In the matter of an application for resource consent by Woolworths New Zealand Ltd to undertake demolition of a building, undertake new building, alterations, and additions and to establish a sign exceeding the maximum size within the Greytown Historic Heritage Precinct; establish an additional vehicle crossing to State Highway 2 (Main Street) Greytown and to undertake associated landscaping and site works.

### Statement of evidence of Terry Phillip Church on behalf of Waka Kotahi New Zealand Transport Agency Traffic

Dated 22 September 2023

**Figure 6: Austroads warrant for turn treatments**

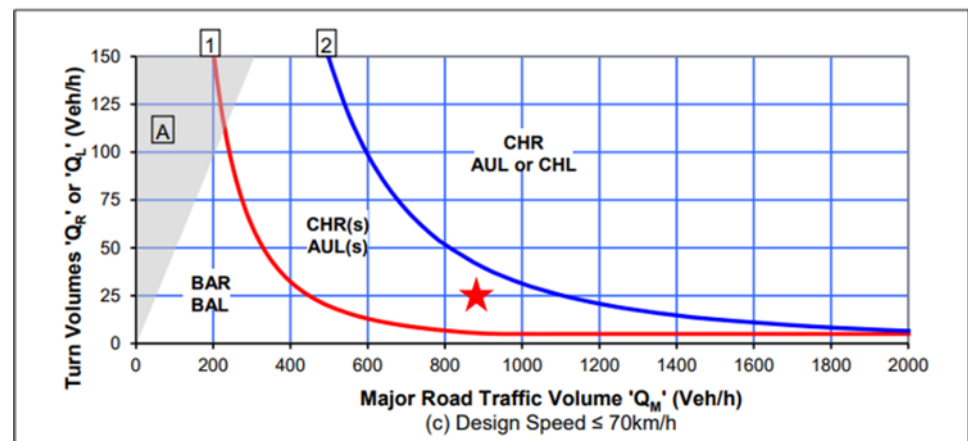
- 9.41 With SH2 having a sign-posted speed of 40km/h, the less than equal to 70km/h design guide has been used, as shown in Figure 6. With the hourly traffic volume on SH2 being 900 vehicles per hour (two way) and the right turn volume being between 25 to 30 vehicles per hour, the warrant requires a channelised right turn treatment with short lane (CHR(s)).

**Figure 7: Austroads Channelised Right Turn treatment design elements**

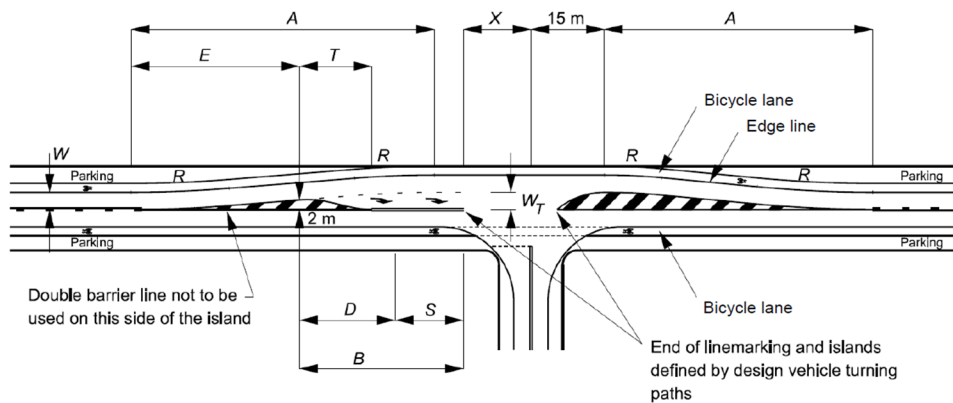
- 9.42 Figure 7 below shows the geometric requirements of providing a channelised right turn treatment (right turn lane) alongside a cycle lane, as per Austroads Guide to Road Design, Part 4A Unsignalised and Signalised Intersections, Section 7.5.2. Based on the width of Main Road fronting the proposed access, there is insufficient width to provide for the elements shown in Figure 7 which include the provision of directional cycle lanes, right turn bay, parking and 3.5m traffic lanes in each direction.

- 9.43 An access that provides sufficient warning to motorists (through the provision of a short right turn lane) may be achievable, but only at the expense of removing a number of on-street parking spaces on both sides of the carriageway (as many as 15 spaces) and regrading the carriageway which currently falls at a steeper cross fall towards the kerb and channel. In addition to a right turn bay, appropriate signage for motorists travelling southbound may not be possible given the narrow access, building awnings and parked vehicles impacting visibility.
